**FINAL DRAINAGE REPORT**

**CIRCLE K at**  
**HIGHWAY 24 & MERIDIAN ROAD**

December 2022

PCD File No. PPR2230

**PROPOSED DRAINAGE MAP**  
 SHEET 2 OF 2  
 DR02  
 ISSUE DATE: DECEMBER 2022

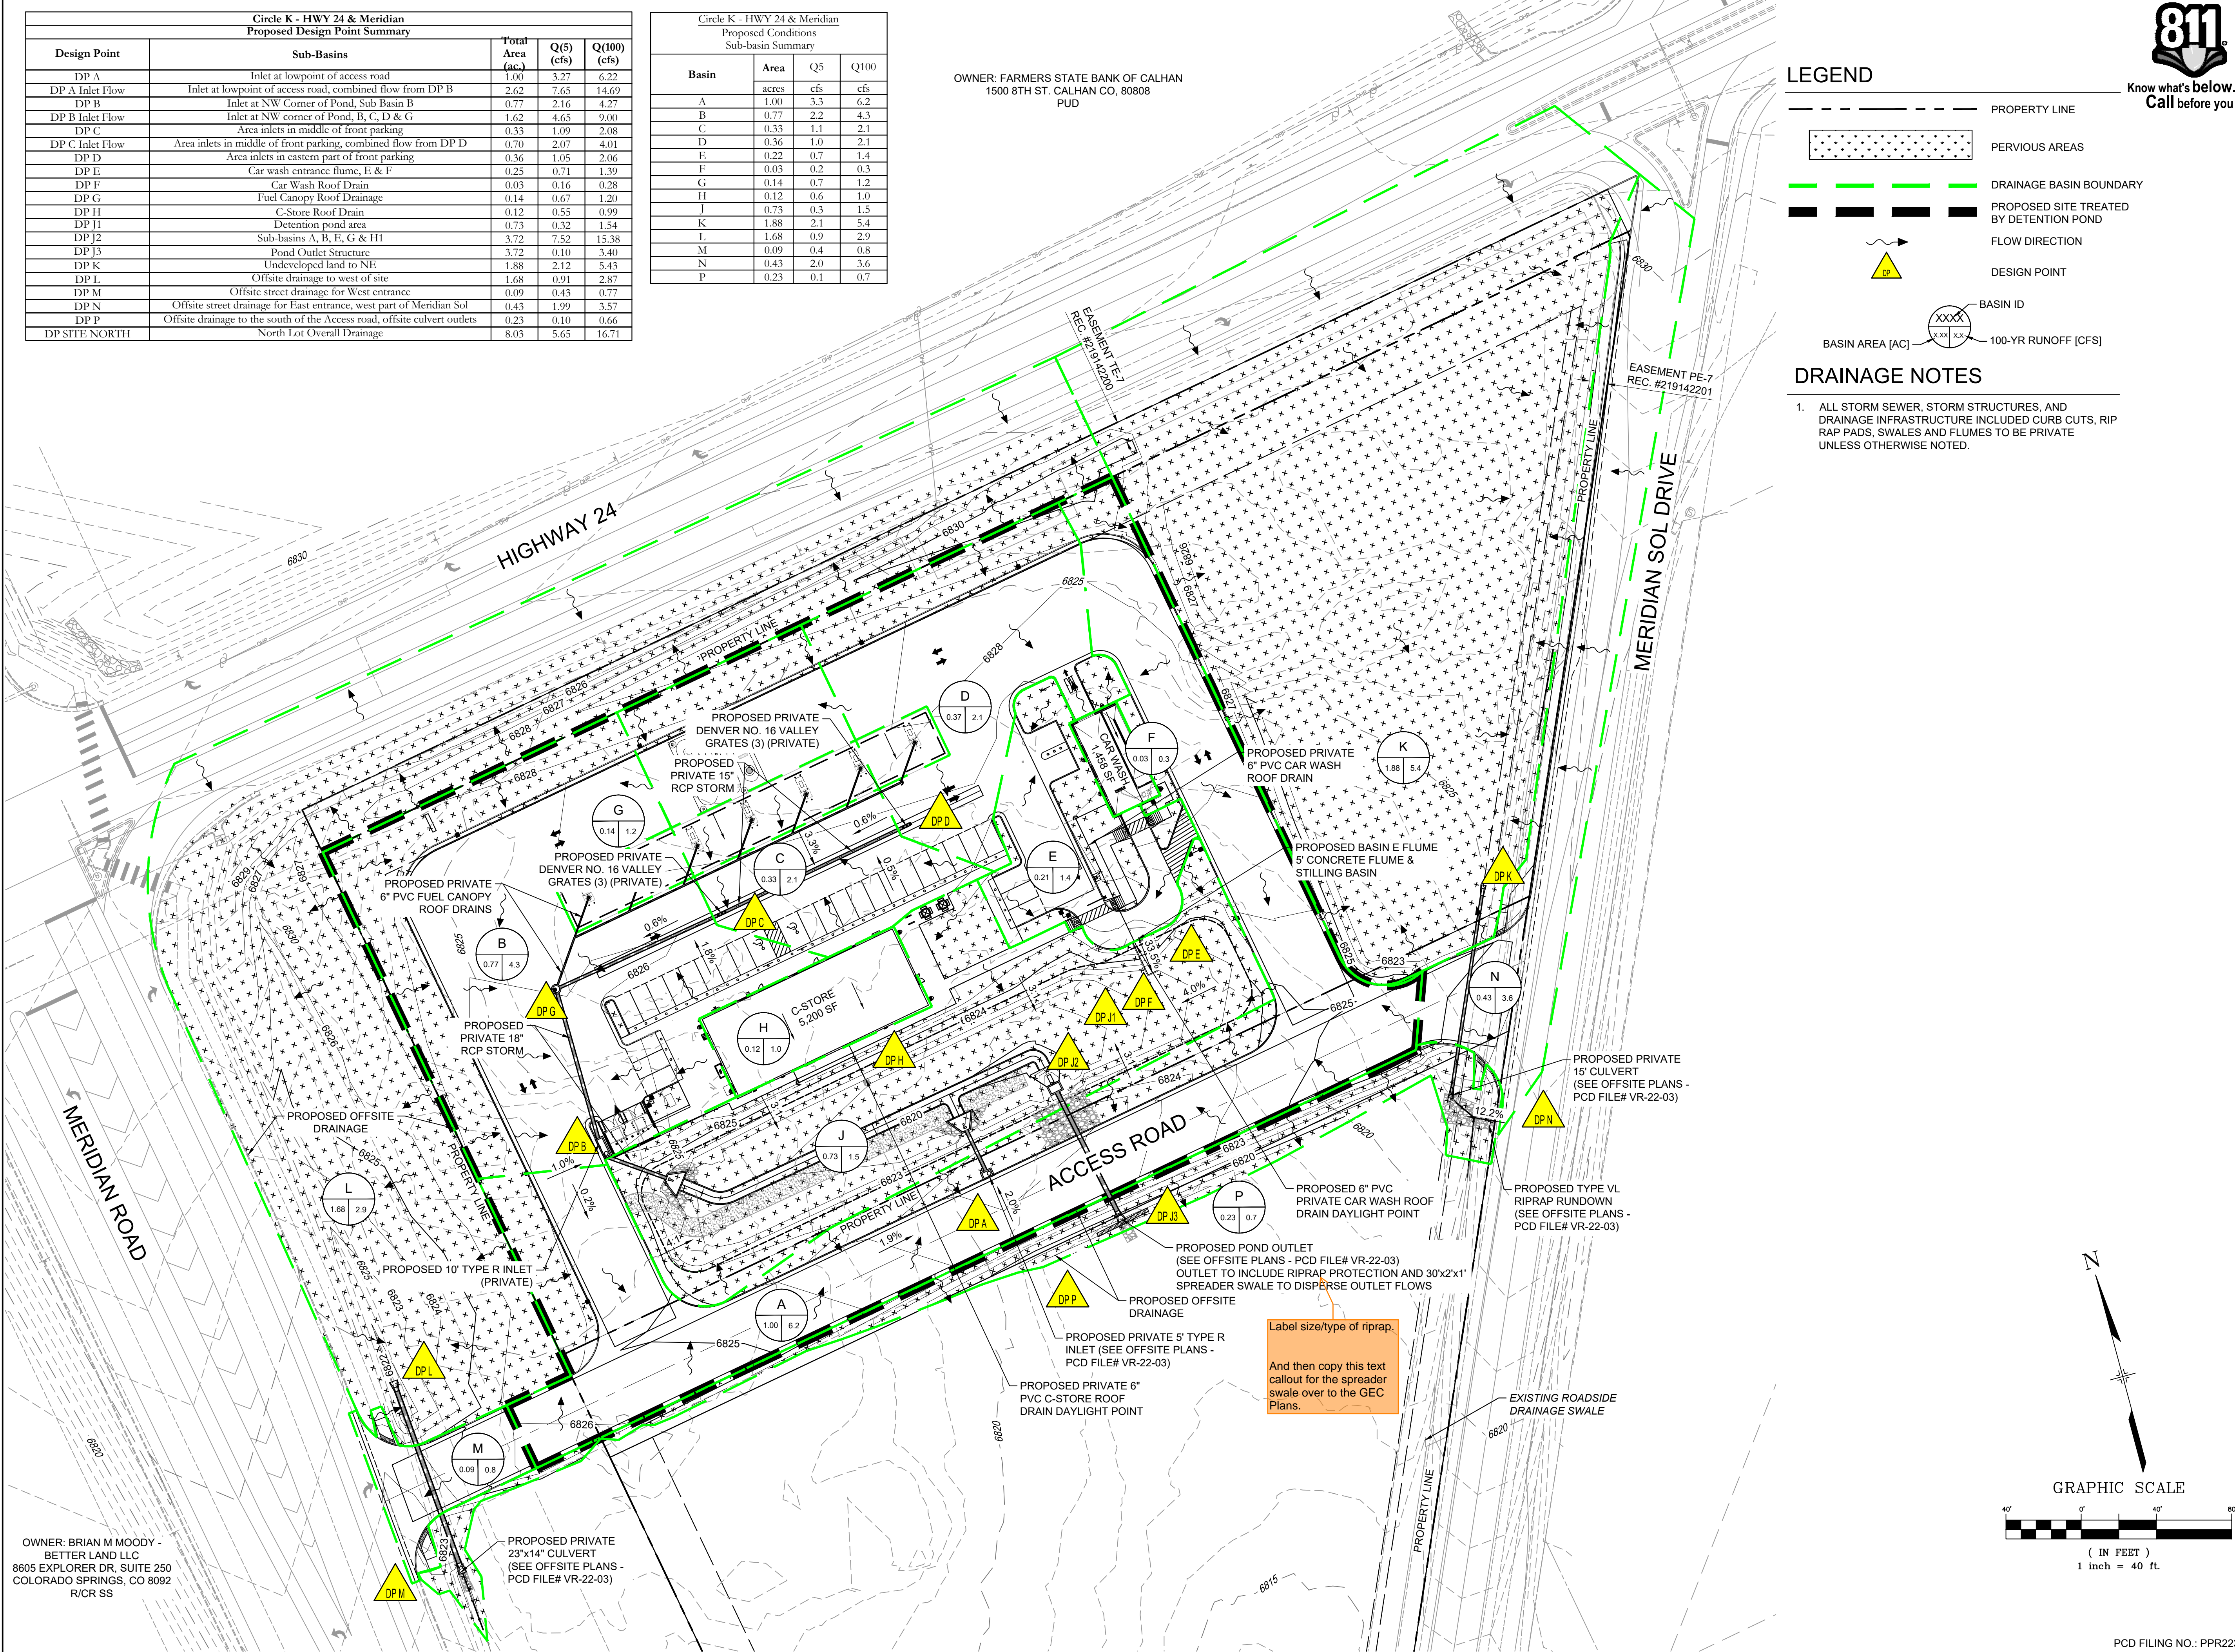
Label size/type of riprap.  
 And then copy this text callout for the spreader swale over to the GEC Plans.
